Year 1 Monitoring Report
Bear Swamp Stream & Wetland Mitigation Project

Monitoring Year 1

NCDEQ Contract No. 7516
DMS RFP No. 16-007337
DMS ID No. 100054
USACE Action ID No. SAW-2018-01154
NCDWR ID: 20180782
Lumber River Basin
HUC 03040203

**RE: Response to Draft MY1 Monitoring Report Comments dated January 24, 2022
Bear Swamp Stream and Wetland Mitigation Site
Lumber River Basin – CU# 03040203 - Robeson County, North Carolina
NCDMS Project # 100054, Contract # 7516**

CURRENT CONDITION PLAN VIEW: ASSET MAP

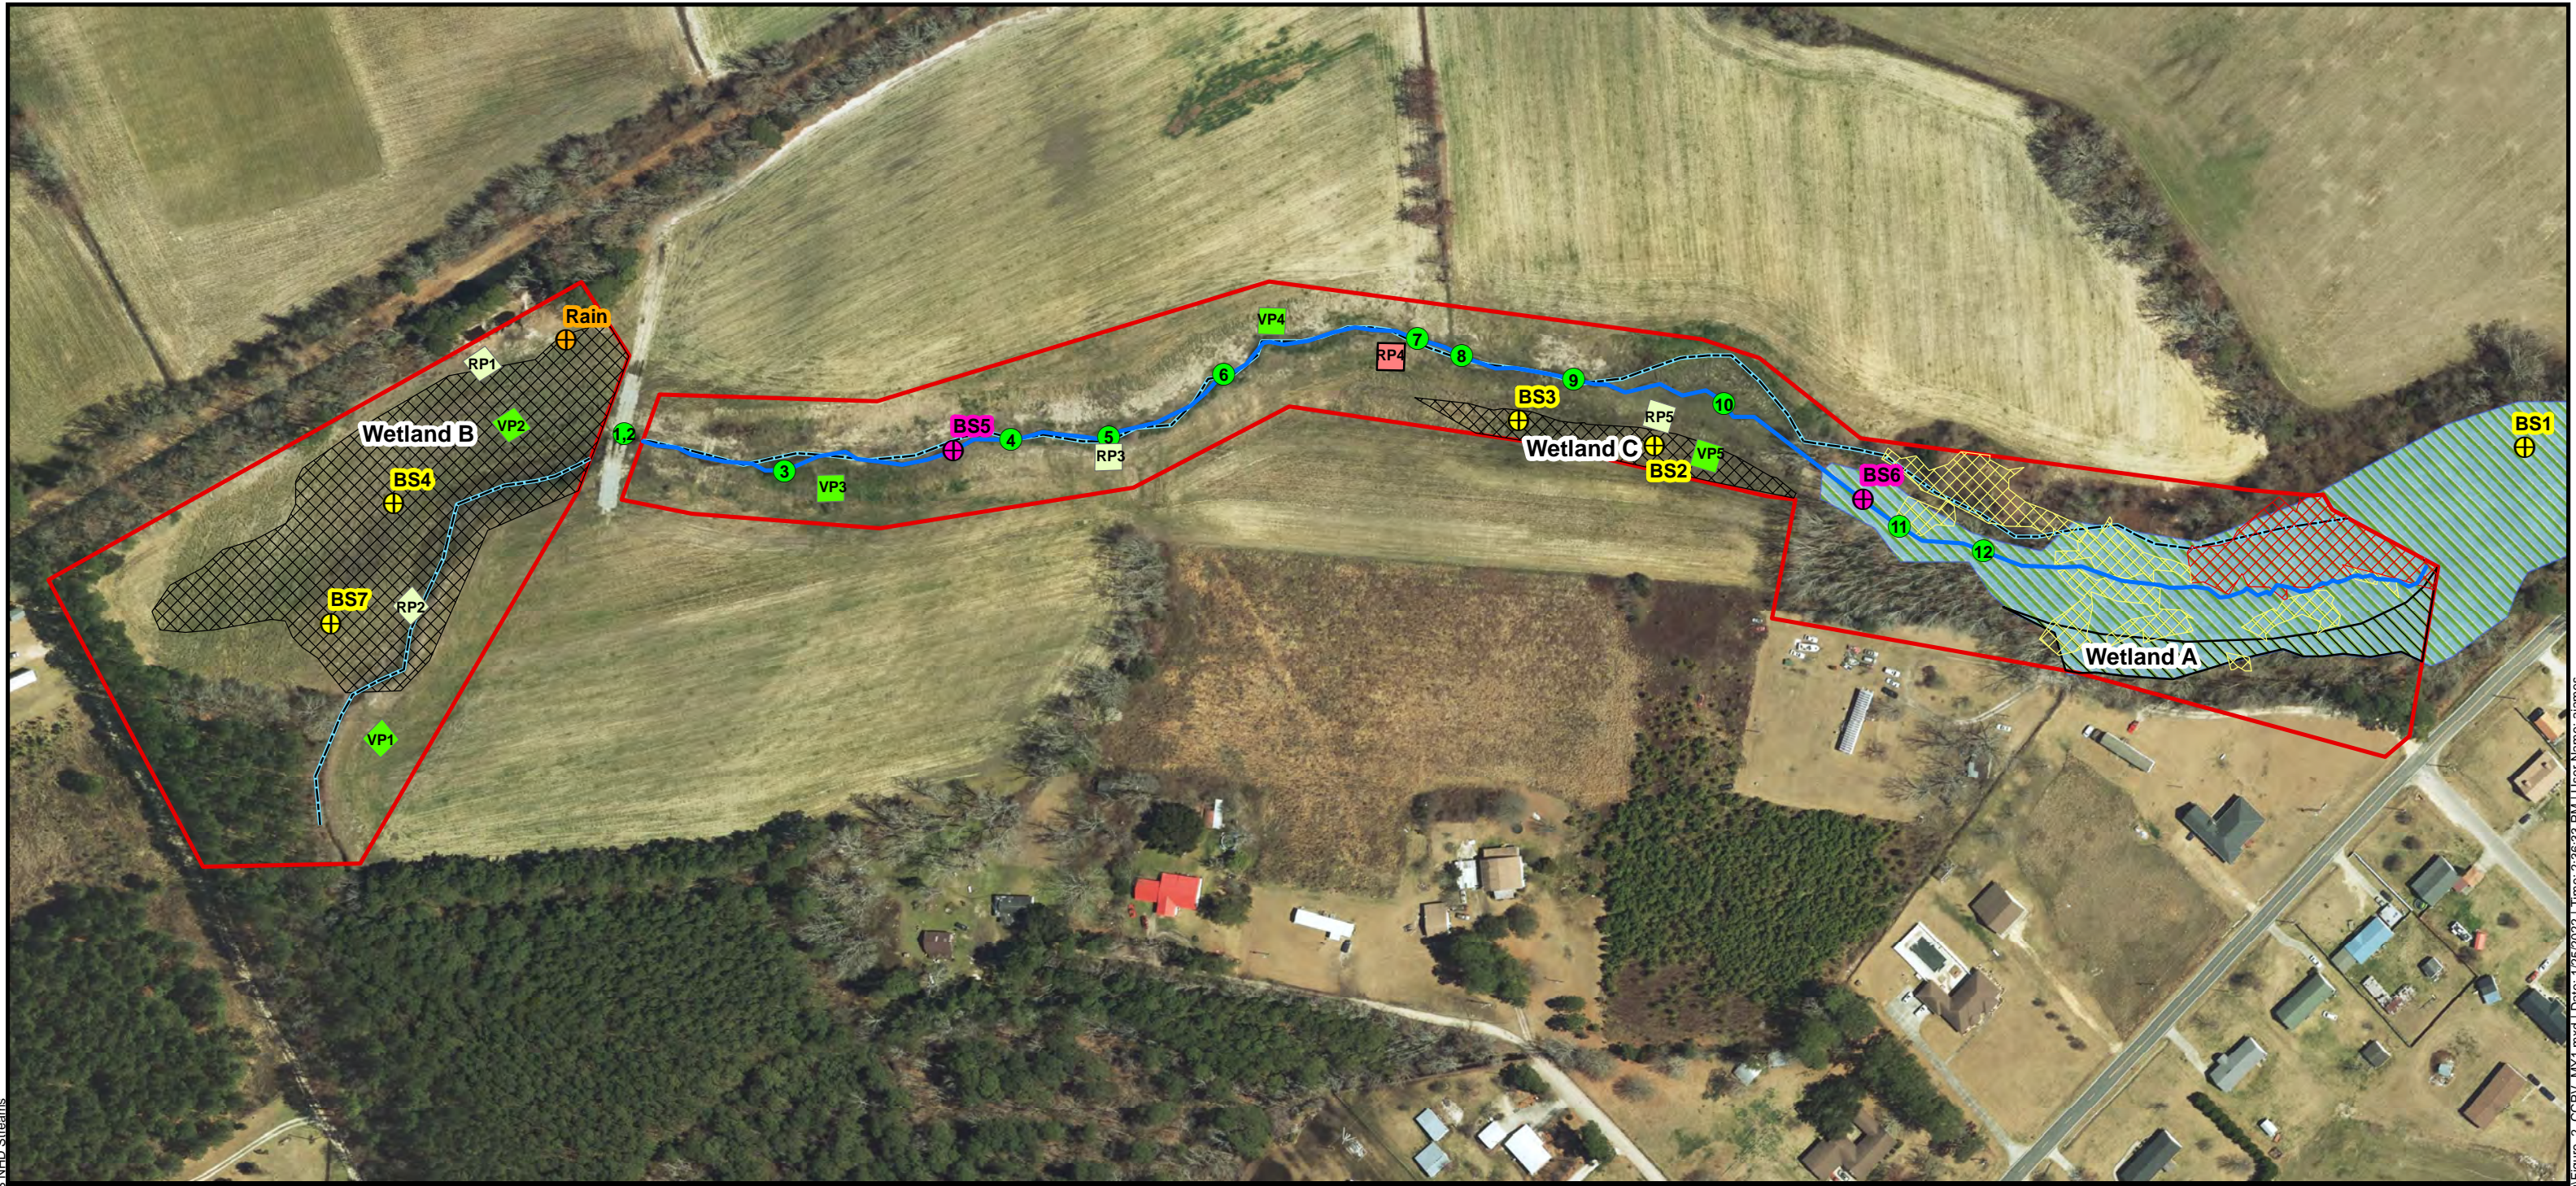
- **CCPV Maps:** *The maximum species concentration is 50%. Please show any vegetation plots that exceed this criteria on the CCPV Map.*
 - **The vegetation plot exceeding the 50% maximum species concentration has been indicated on the CCPV.**

Bear Swamp Stream and Wetland Mitigation Project
Figure 3. Monthly Rainfall Data
Monitoring Year 1 - 2021

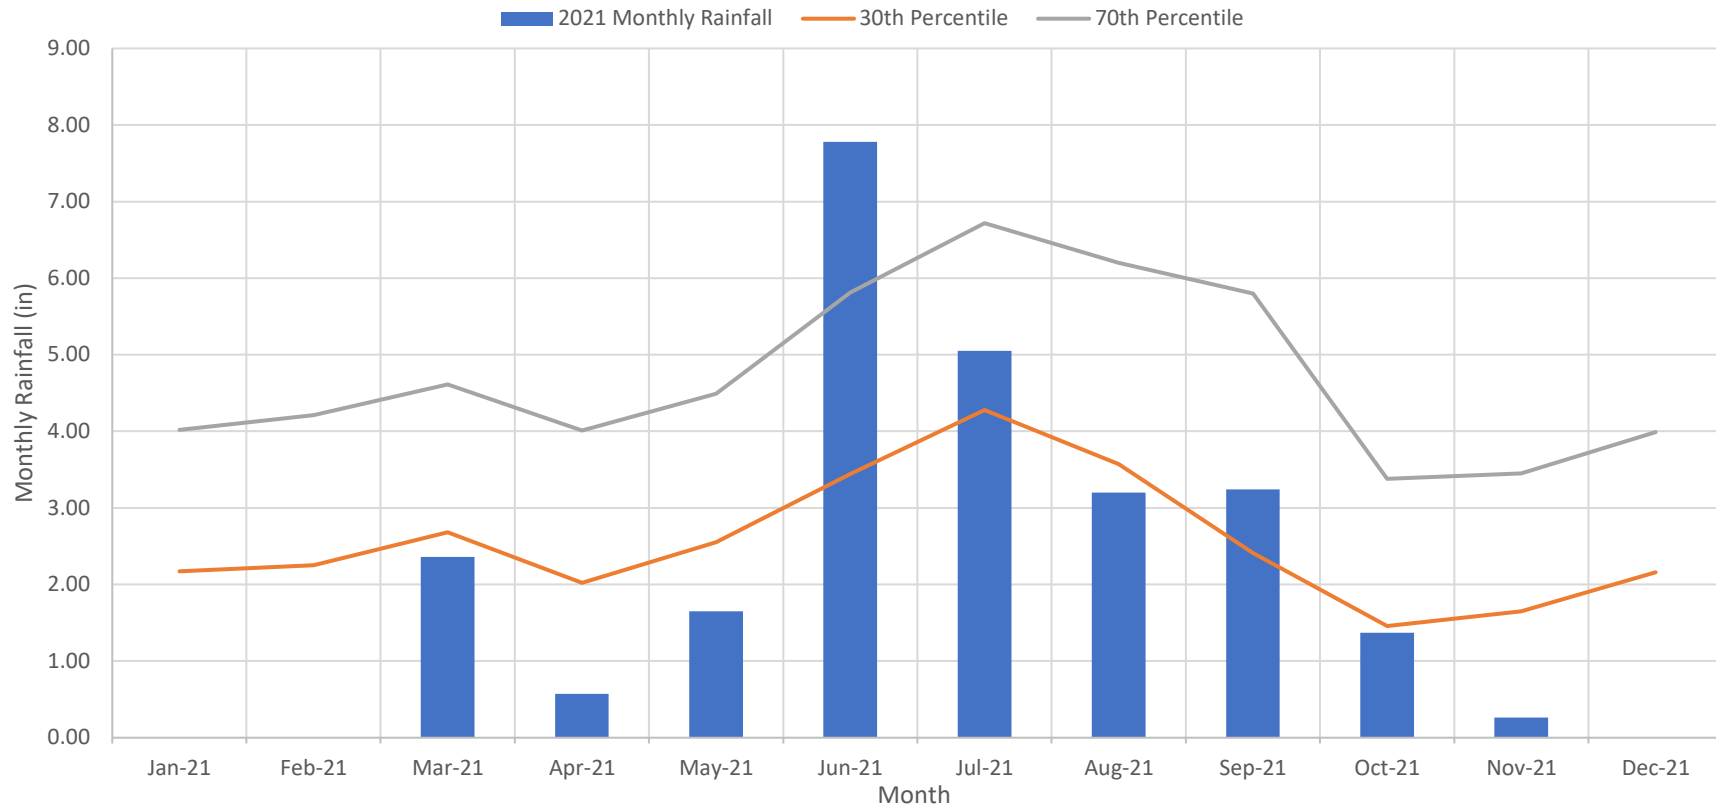
- **2.1.4 Stream Hydrology:** *Rain gauge data are required per the approved mitigation plan. Data collection ceased after October 10th due to the gauge memory being full. Please revise the field methodology or equipment to prevent loss of data during MY2.*

- **Noted.**
- **2.2.1 Vegetation Monitoring Data:** *Include discussion of the performance criteria for height requirement at years 5 & 7 and indicate how this metric was addressed during MY1.*
